JENISHAY FARMS Preliminary Plan El Paso County, Colorado

EL PASO COUNTY
PRE-DEVELOPMENT
COVER SHEET

EL PASO COUNTY
PRE-DEVELOPMENT
PRELIMINARY PLAN
NOTES

C2
SHEET NO.

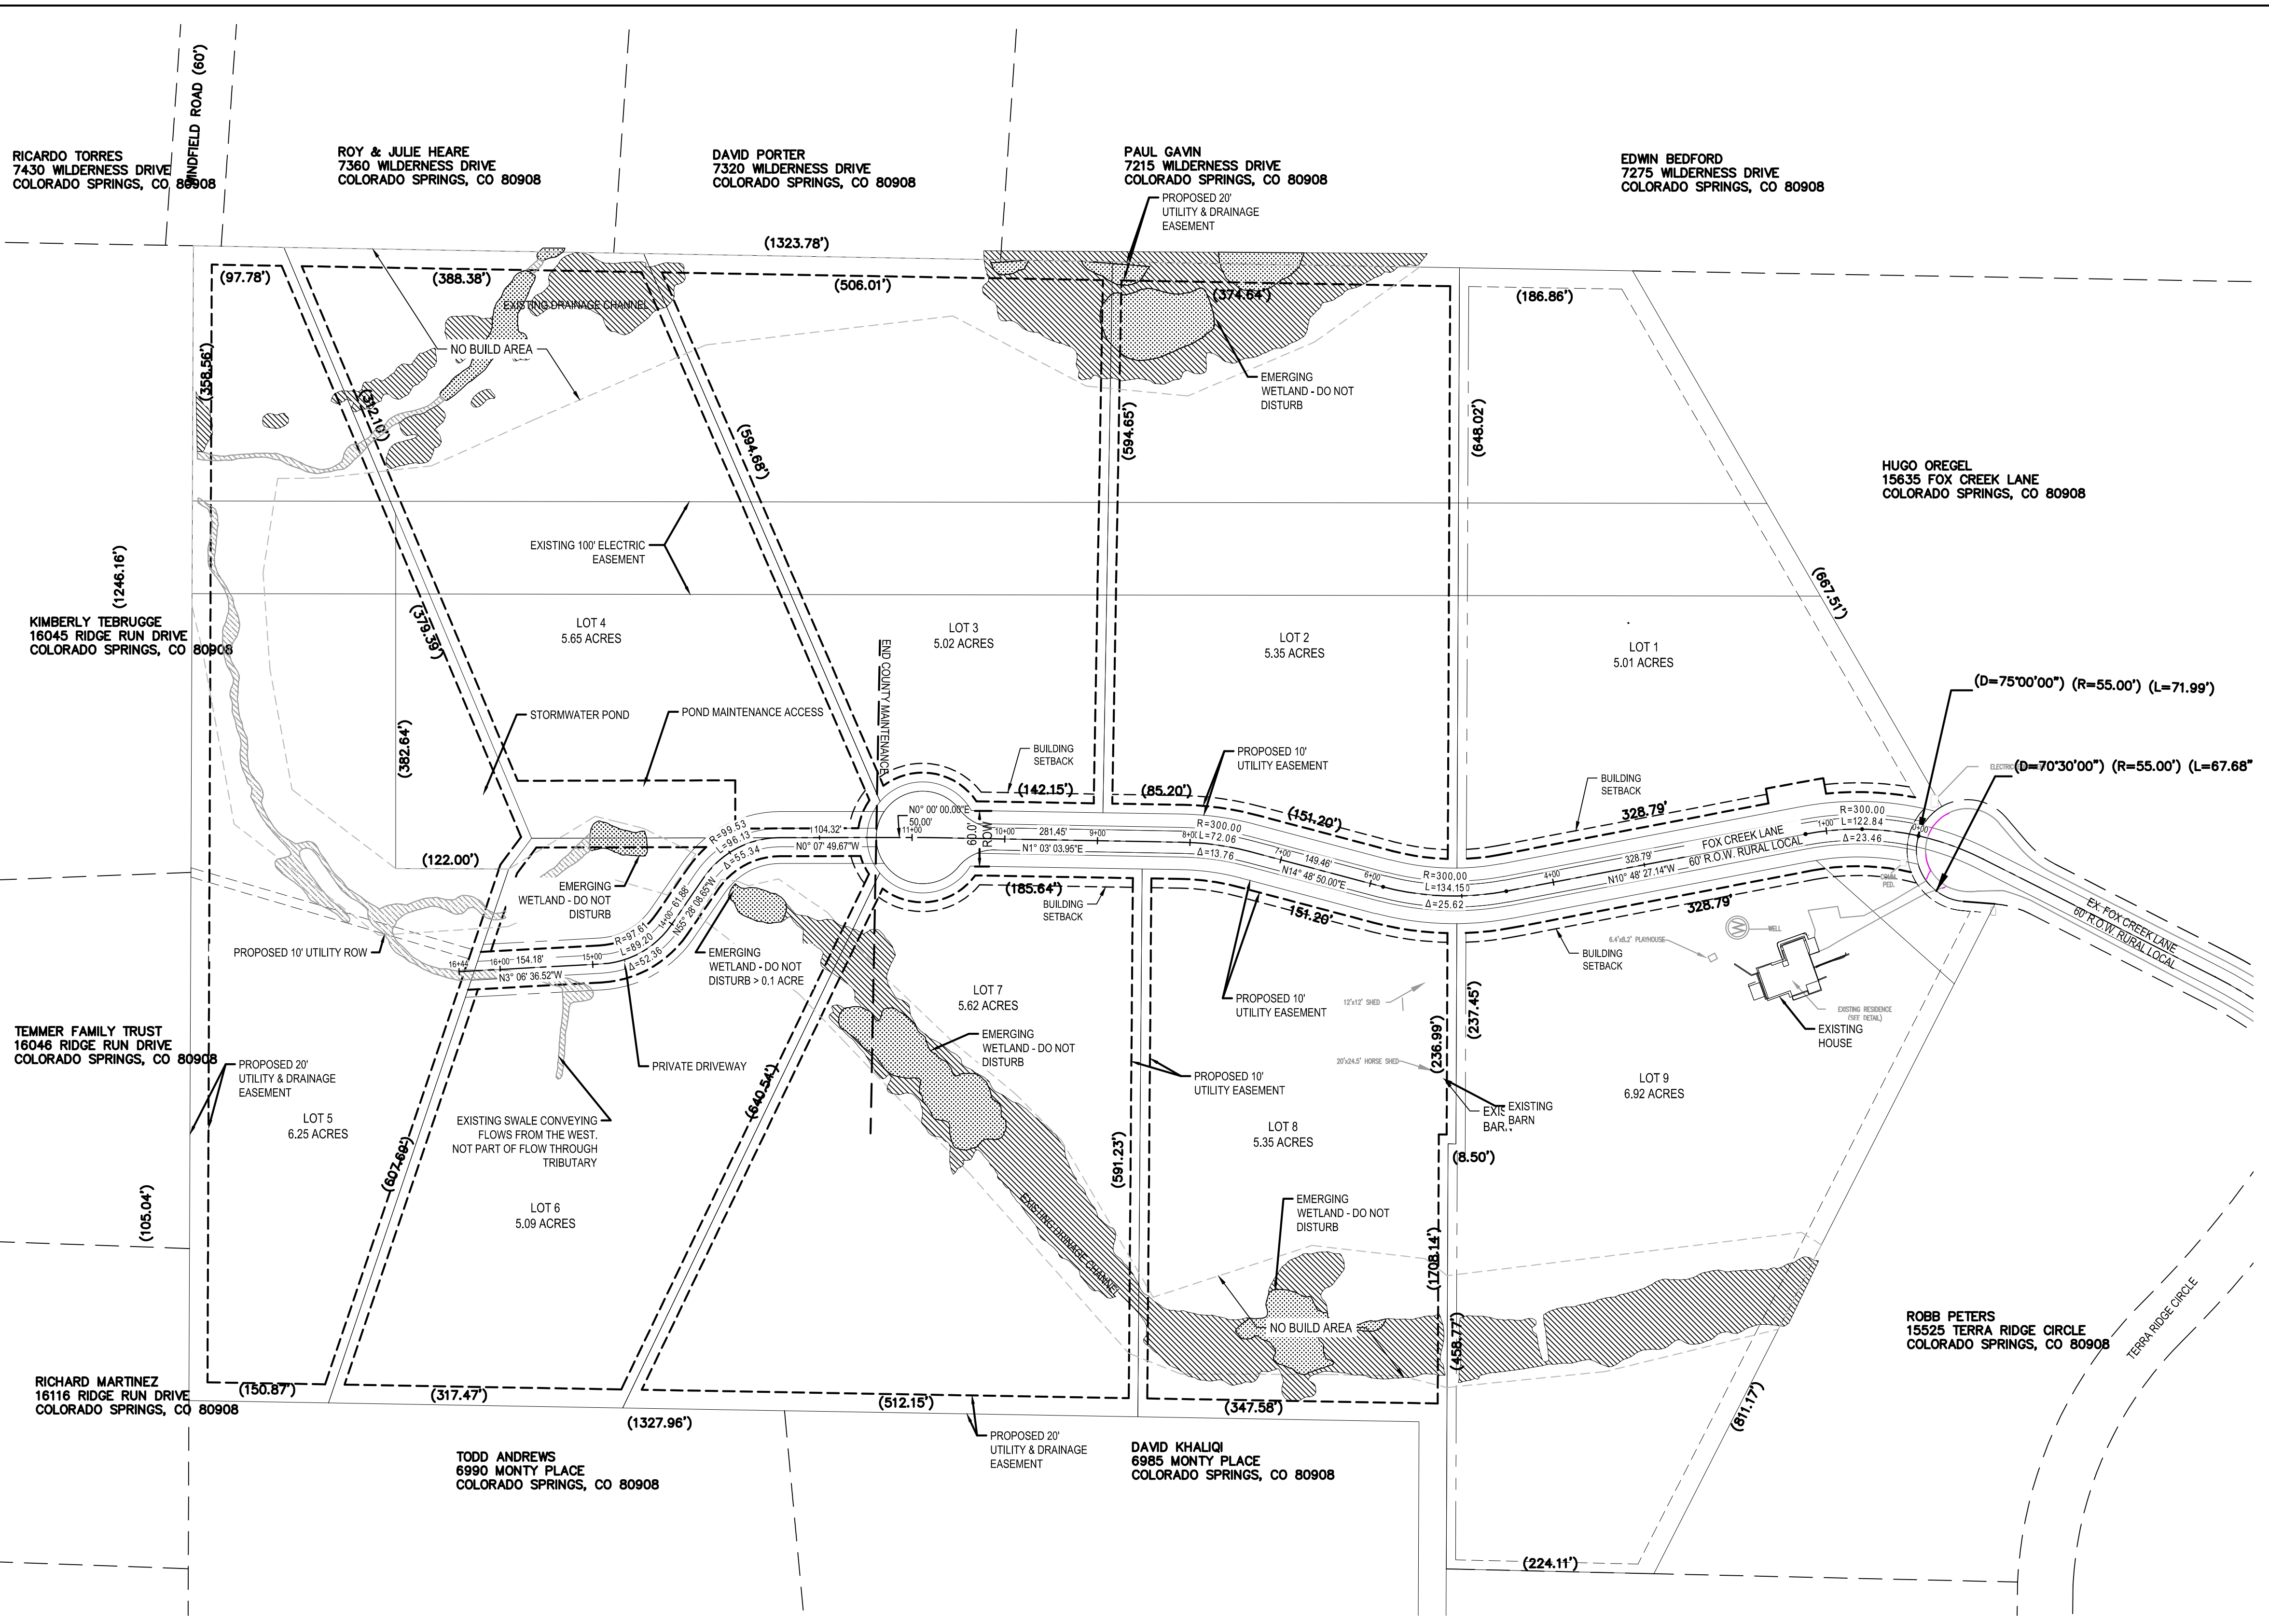
Unresolved comment from Review #1:

16. Soil erosion control measures for all slopes, channels, ditches, or any disturbed land area shall be completed within twenty-one (21) calendar days after final grading, or final earth disturbance, has been completed. Disturbed areas and stockpiles which are not at final grade but will remain dormant for longer than 30 days shall also be mulched within 21 days after interim grading. An area that is going to remain in an interim state for more than 60 days shall also be seeded. All temporary soil erosion control measures and BMPs shall be maintained until permanent soil erosion control measures are implemented.

Unresolved comment from Review #1:
Per DCM Vol 2, Chapter 3.3: 'Seed any disturbed areas that are to remain in an interim state for more than 60 days, but less than one year.'
Clarify note 6 per req's of DCM above.
